# OAKLAND BICYCLE MASTER PLAN

Final Environmental Impact Report  
*State Clearinghouse No. 205092011*

Prepared for  
City of Oakland

September 2007

Figure 3-1C

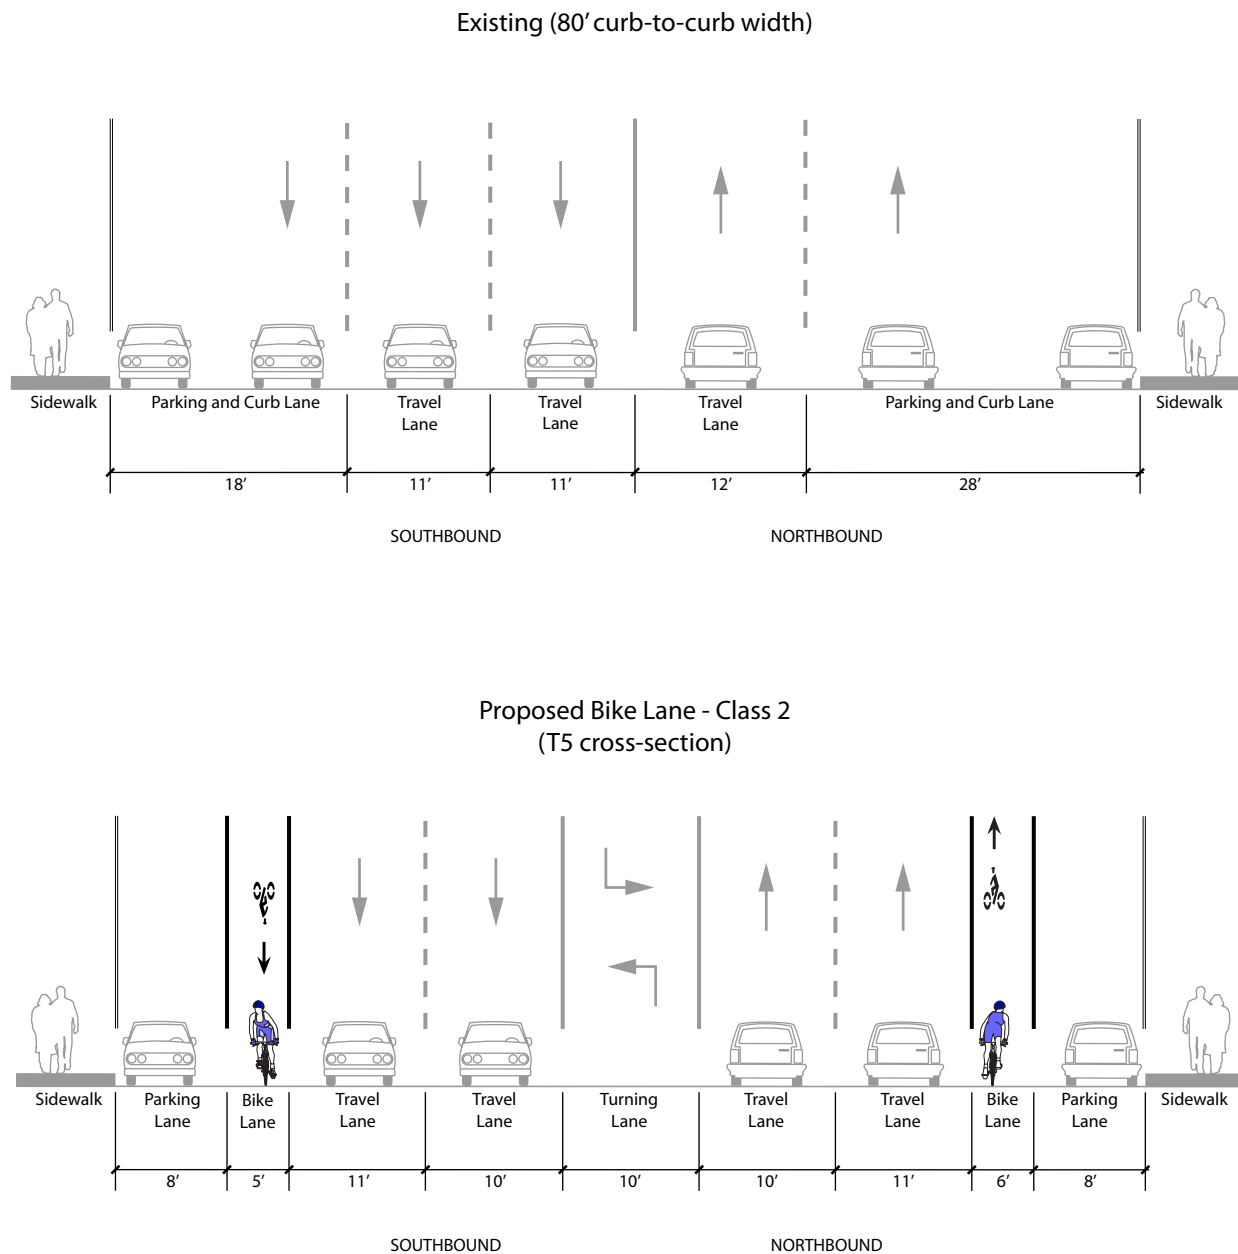
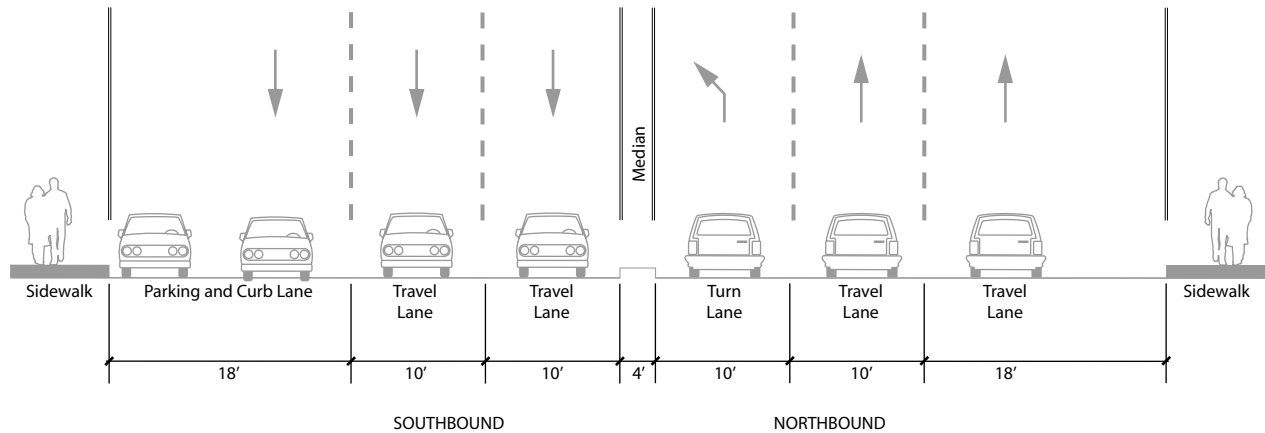
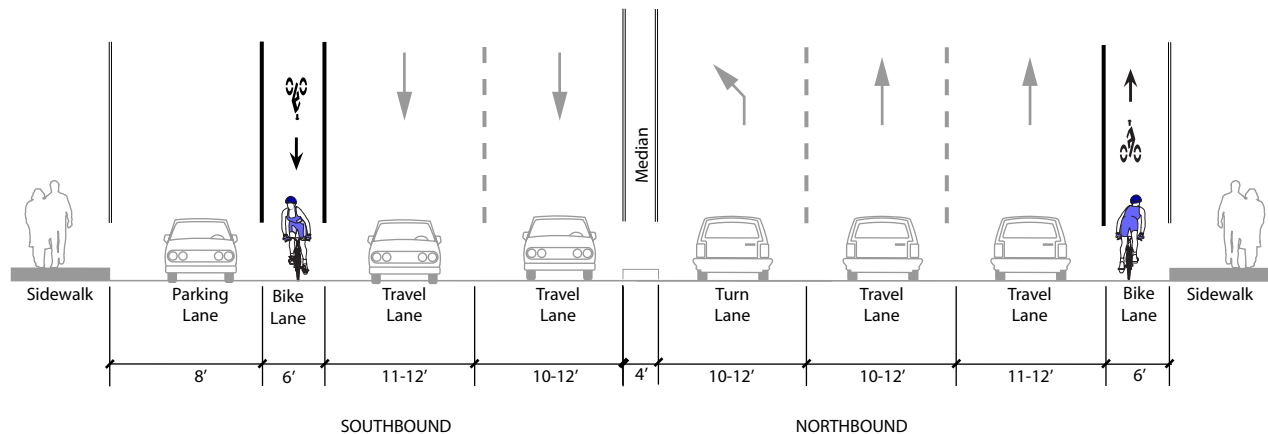
*Figure 3-1C: Proposed Cross-sections was revised and is presented in Appendix B.*

Figure 3-1D

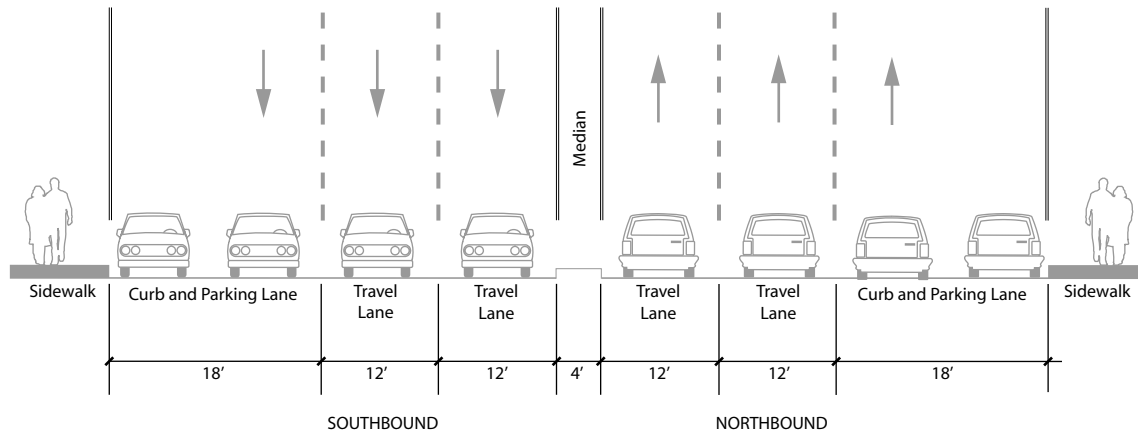
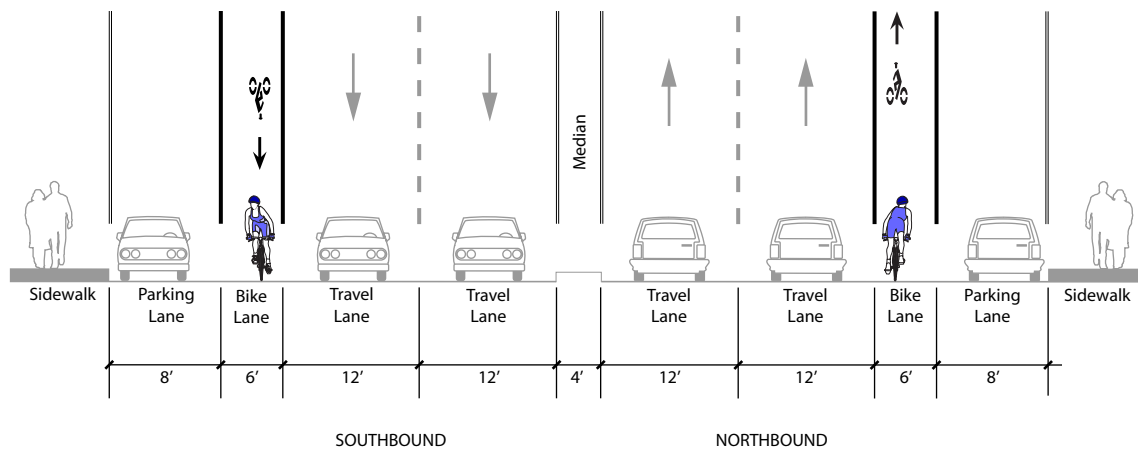
*Figure 3-1D: Proposed Cross-sections was revised and is presented in Appendix B.*
